10-E-22-HZ
APPLICATION FOR CERTIFICATE OF APPROPRIATENESS

1401 Forest Ave. 37916
Ft. Sanders NC

Staff Report

File Number: 10-E-22-HZ

① SITE PLAN
1/16" = 1'-0"

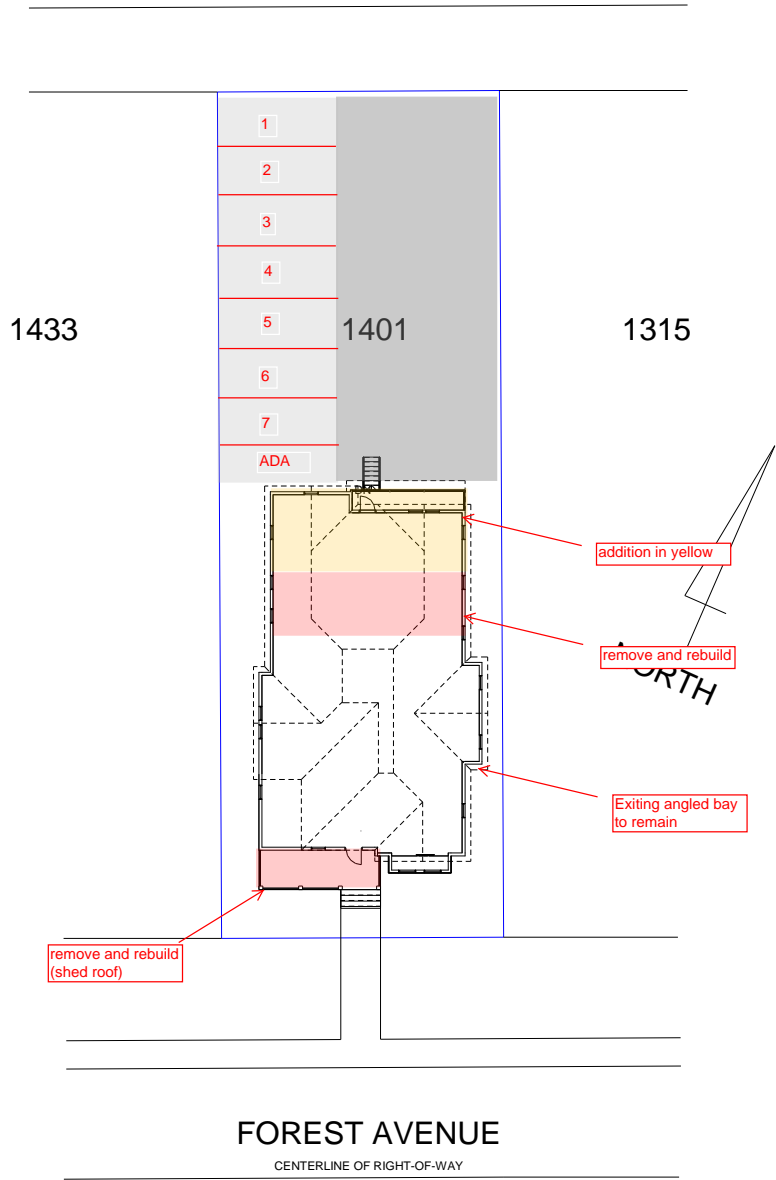
5. The site plan for the east elevation (side elevation 1) indicates the existing angled bay will be retained, though floor plans and elevation drawings do not reflect it. Final drawings by architect (submitted for permitting, versus preliminary drawings submitted to HZC by the drafter) should clearly show the angled bay.

10. Final modifications to the site plan will be necessary to meet City Engineering standards for parking. The house and parking area need to remain below 45% impervious surface for the RN-5 zoning. The final site plan could be approved by staff, provided there are no substantial modifications to the addition's design and placement.

roof to match the design and pitch of the existing; 2) angled bay on east side elevation to be retained; 3) final drawings to indicate eave overhangs, cornice returns, and appropriately-sized cornerboards, window, and door trim; 4) final site plan to meet City Engineering standards for parking and dimensional standards of base zoning, with minor modifications to be approved by staff; 5) architect-drawn elevations to be submitted to staff for approval prior to permitting, and providing for discussion from the Commission on the three different applications of fiber cement siding.

① SIDE ELEVATION 1
1/8" = 1'-0"

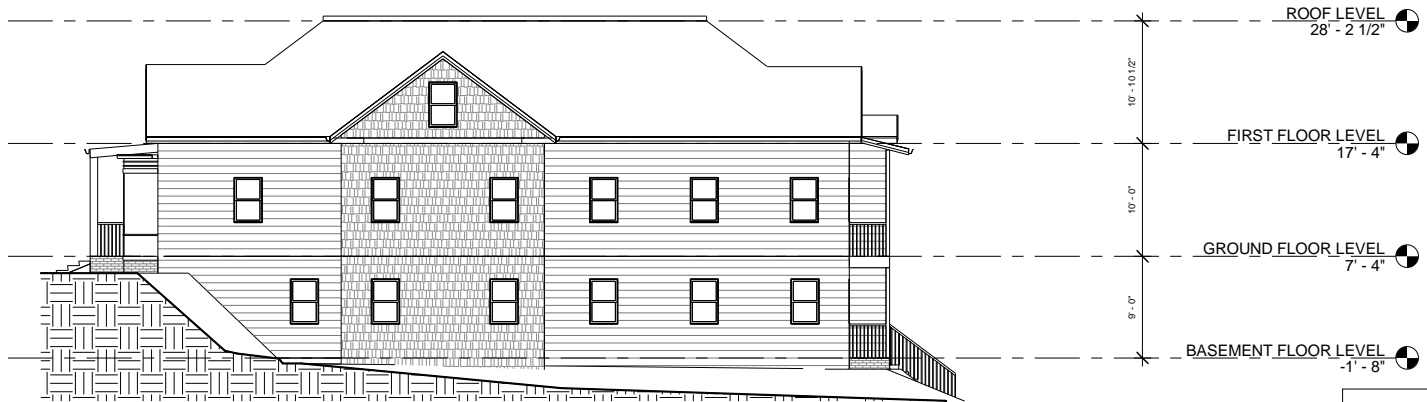
3. Reconstruction of the front porch roof and foundation meets the design guidelines. The reconstructed porch roof should match the design and pitch of the existing.
